#### Descriptive Report to Accompany Hydrographic Survey H12276

Project OPR-N338-NRT3-10 Columbia River Harrington Point to Three Tree Point Scale 1:10,000 October 2010 to January 2011 NOAA NRT-3 (S1212)

#### **Revisions and corrections performed during office processing and certification.**

Figure 5: H12276 Junction surveys.

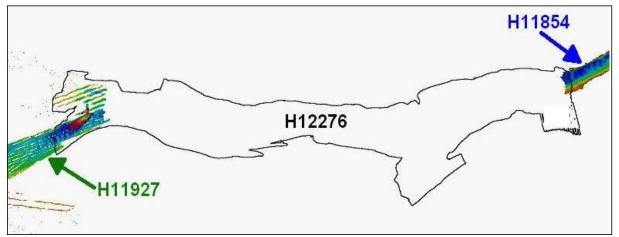
Survey H12276 junctions with H11854 to the East, and with H11927 to the West<sup>1</sup> (Table 4, Figure 5). Bathymetric Attributed Grids (BAG) of H11854 and H11927 were provided by the Navigation Response Branch for junction comparison. The area of overlap between the sheets was reviewed in CARIS HIPS using the cursor information tool. Due to the long time between surveys and to the extremely dynamic nature of the Columbia River bottom, which includes migrating sand waves, scouring and deposition, substantial differences were seen between H12276 and its junction surveys.<sup>2</sup>

<sup>&</sup>lt;sup>1</sup> H12276 junctions with H11854 to the East, and H11927 to the West. A common junction was made with the adjoining portion of these surveys.

<sup>&</sup>lt;sup>2</sup> Due to the dynamic nature of the seabed and constant changes along the Columbia River, the compiler recommends adding a cautionary note to the chart. Use caution when navigating outside of maintained channels.

Figure 6: six-meter horizontal sand wave migration.

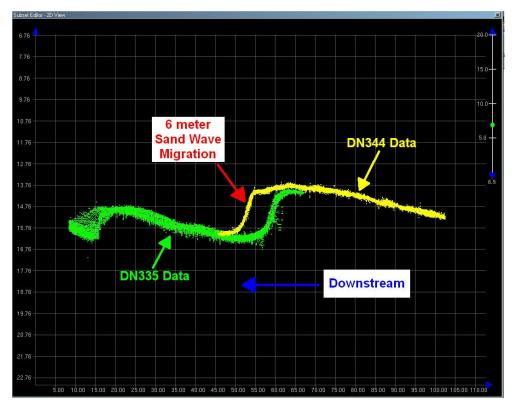
Due to the dynamic nature of the Columbia River, strong currents, significant sediment transport, sand wave migration and other related factors, data quality was adversely affected in some areas of the survey. The greatest evidence of this is found where overlapping data was acquired many hours to days apart, as with crosslines. For this reason, crosslines were not incorporated into BASE surfaces but were used for analysis. Figures 6 and 7 illustrate a six-meter horizontal offset and BASE surface artifacts caused by sand wave migration over a nine (9) day period.<sup>3</sup>

<sup>&</sup>lt;sup>3</sup> Data is adequate to supersede charted data in the common area despite the nature of the sand wave migration. Shoalest soundings are depicted in the HCell. See endnote 2.

Figure 13: H12276 Sounding comparison, western survey area.

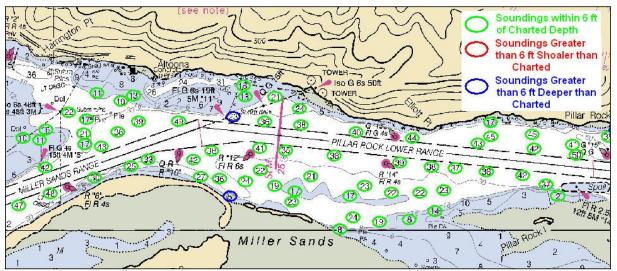
H12276 soundings are generally deeper than charted. Soundings agreed with charted (18523) depths to within 6 feet across all depth ranges except as indicated in Figures 13 and 14. Green circles in Figures 13 and 14 indicate where H12276 soundings are within 6 feet of charted depths, red circles indicate where soundings are greater than 6 feet shoaler than charted, and blue circles indicate where H12276 soundings were greater than 6 feet deeper than charted.<sup>8</sup>

<sup>8</sup> Concur with clarification. Chart soundings as shown in the HCell.

Figure 16: Chart 18523 before and after H12276 DTON 3.

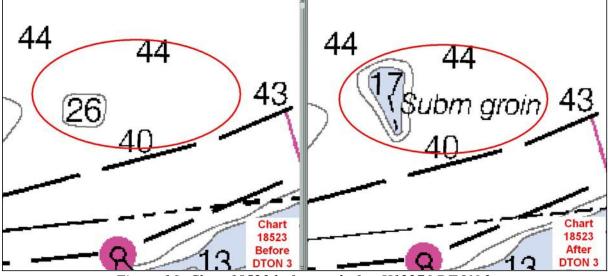
Three (3) Dangers to Navigation (DTONs) were found on survey H12276 and reported to the Marine Chart Division via email on April 13, 2011. The original DTON submission package is included in Appendix I.<sup>13</sup> Figures 15 and 16 depict print on demand chart 18523 before and after H12276 DTONs were applied.

Note: As of April 25, 2011, the submerged groin depicted in figure 16 was not applied to ENC US5OR12M.

<sup>13</sup> DTON report is attached to this report and all DTONS have been applied to the latest chart. For DTON # 3, an obstruction feature was added to the HCell to supersede the charted 17 ft. at 46-15-44.034N, 123-32-39.191W.

Figure 2.2.1

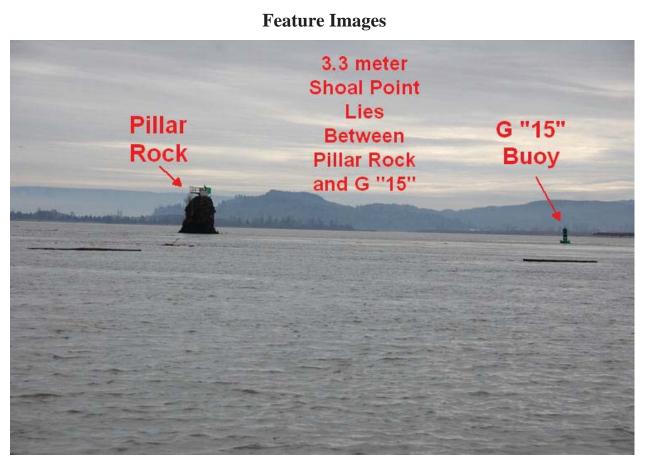
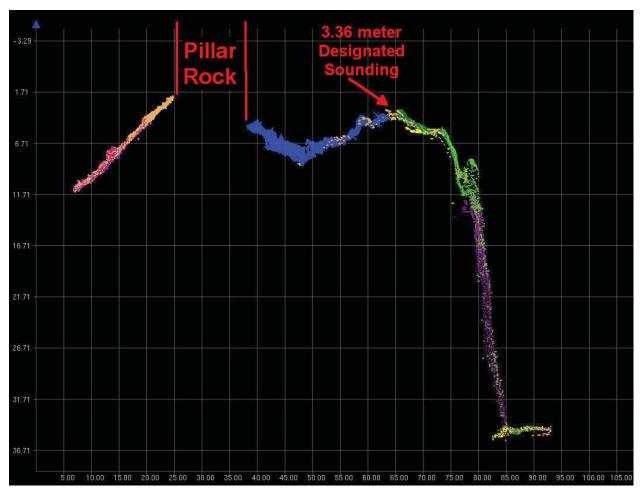
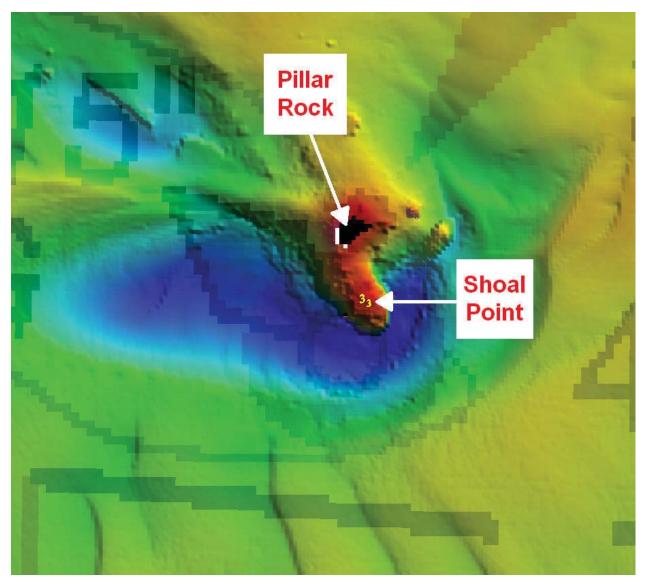
3.3m rock at position 46-15-27.91N, 123-35-13.34W. Approx 28 meters south of Pillar Rock. Shoal point is within the 60 foot depth contour on chart 18523. 3.3m rk is between Pillar Rock (islet) and the G "15" buoy. Although outside the channel, some vessels could attempt to pass between Pillar Rock and the G "15" buoy since there is no indication on chart 18523 that a 3.3 meter rock exists in the vicinity.

Chart (18523) 3.3 meter rk at position 46-15-27.91N, 123-35-13.34W.

<sup>12</sup> Feature report is attached to this report. Do not concur with the hydrographers

recommendation of charting the 3.3m rock at position 46-15-27.91N, 123-35-13.34W. At chart scale the rock symbol will not fit on the chart because the rock is between the charted Pillar Rock (islet) and the charted G "15" buoy.
